PT5300 Front panel modifications for LCD MC240005AA6W9-BNMLW.

Figure 1.

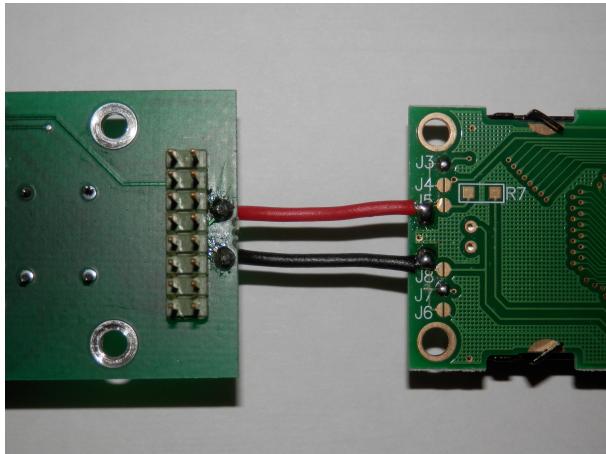
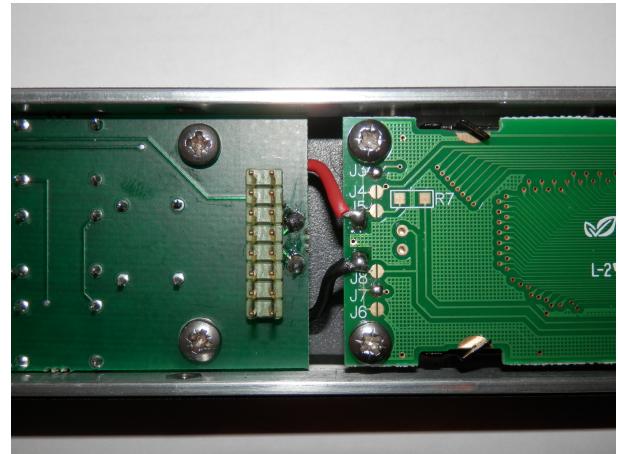
When using the LCD display MC24005AA6W9-BNMLW the backlight must be connected to the keyboard as shown in figure 1 and 2.

Figure 3.

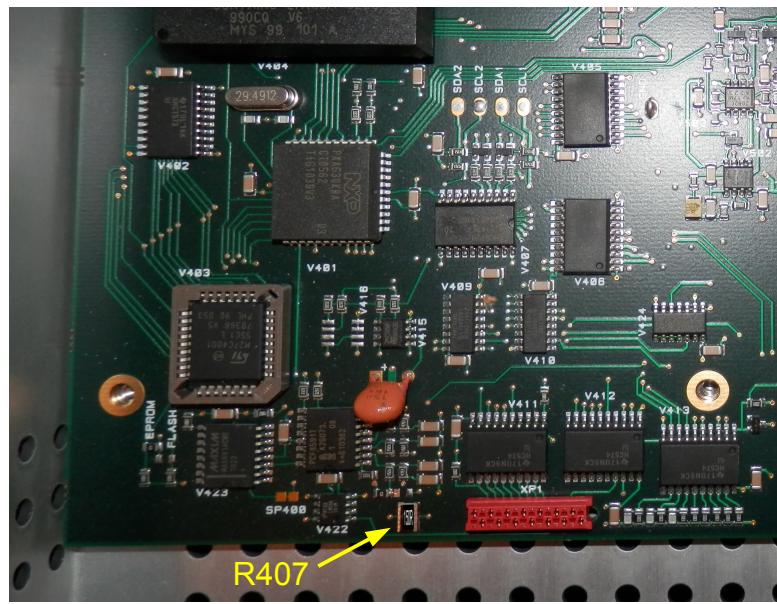
Resistor R407 on the PT5300 main board must be changed from 3R9 to 150R 1W as shown in figure 3.

Figure 4.

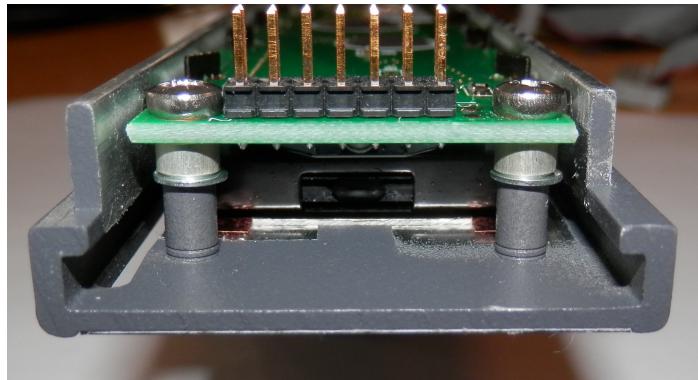
M3 x 10 mm. pan head screws are used when mounting the display.

A spacer with a length of 3.5 mm. is inserted between the display and the front panel as shown in figure 4.
